Project	IEEE 802.16 Broadband Wireless Acces	s Working G	<pre>Group <http: 16="" ieee802.org=""></http:></pre>				
Title Date Submitted Source(s)	TEK generation and update for Handov	TEK generation and update for Handover					
	2008-03-17						
	Kyeong-Tae Do Eun-Sun Jung	Voice: E-mail:	+82-31-279-5748 kyeongtae.do@samsung.com esleon.jung@samsung.com				
	Geunhwi Lim		esteon.jung@samsung.com				
	Samsung Electronics Co., LTD						
Re:	LB 26b						
Abstract	The effort to reduce the HO latency is currently being discussed. Main idea is to exchange in the serving BS the information which is required at the target BS. This contribution suggests the way of sharing TEKs.						
Purpose	Accept the proposed specification changes on IEEE P802.16Rev2/D2						
Notice	<i>This document does not represent the agreed views of the IEEE 802.16 Working Group or any of its subgroups.</i> It represents only the views of the participants listed in the "Source(s)" field above. It is offered as a basis for discussion. It is not binding on the contributor(s), who reserve(s) the right to add, amend or withdraw material contained herein.

## **TEK generation and update for Handover**

#### IEEE C802.16maint-

Figure. Proposed TEK exchange scheme

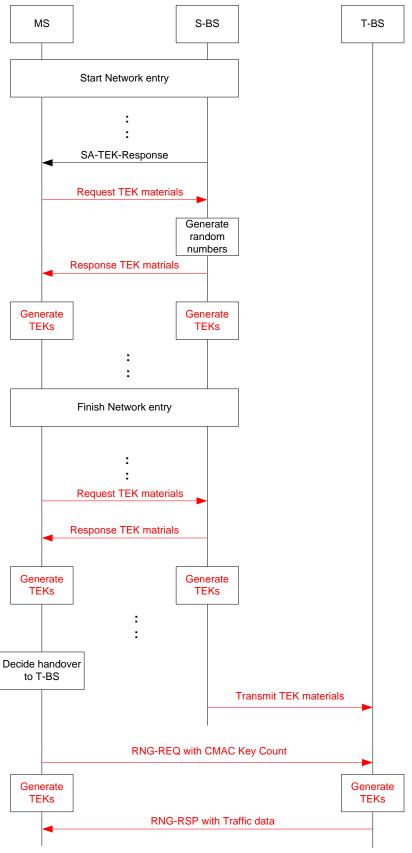
In this document, we suggest changing current TEK delivery scheme to share the TEKs at the target BS. We suggest that The TEK nonces, not TEKs, should be exchanged during the network entry and TEK refresh. When TEK encryption algorithm is "generate TEKs with TEK materials" which is newly added for this scenario, PKMv2 Key-Material-Request and Key-Material-Reply messages are exchanged instead of PKMv2 Key-Request/Reply messages. PKMv2 Key-Material-Reply message includes TEK nonces which are used to generate TEKs. After exchanging these messages, both MS and BS generate TEKs separately. Upon expiration of TEK refresh timer, PKMv2 Key-Material-Request and Key-Material-Reply messages are exchanged to deliver TEK nonces.

During the HO, the latest TEK nonces at the serving BS are transferred to the target BS. The target BS generates new TEKs with the TEK nonces from the serving BS and TEK counter which is incremented for every HO trial. TEK counter prevents from using the same TEKs in the case the MS performs handover to the BS previously visited. When CMAC is supported, CMAC Key Count is used for TEK counter. This scenario does not need to expose the new TEKs to the serving BS. Another preparation for TEK sharing scheme is not needed either.

Figure 164 – TEK state machine flow diagram

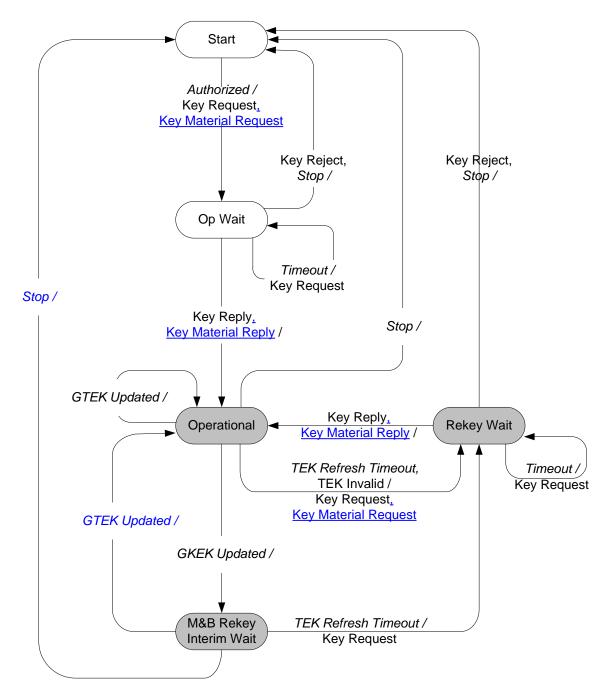
The TEK state machine consists of <u>sevenfive</u> states and <u>eleventen</u> events (including receipt of messages) that may trigger state transitions. Like the Authorization state machine, the TEK state machine is presented in both a state flow diagram (Figure 164) and a state transition matrix (Table 206). As was the case for the Authorization state machine, the state transition matrix shall be used as the definitive specification of protocol actions associated with each state transition.

Shaded states in Figure 164 (Operational, Rekey Wait, Rekey Reauthorize Wait, and M&B Rekey Interim Wait) have valid keying material and encrypted traffic may be sent.
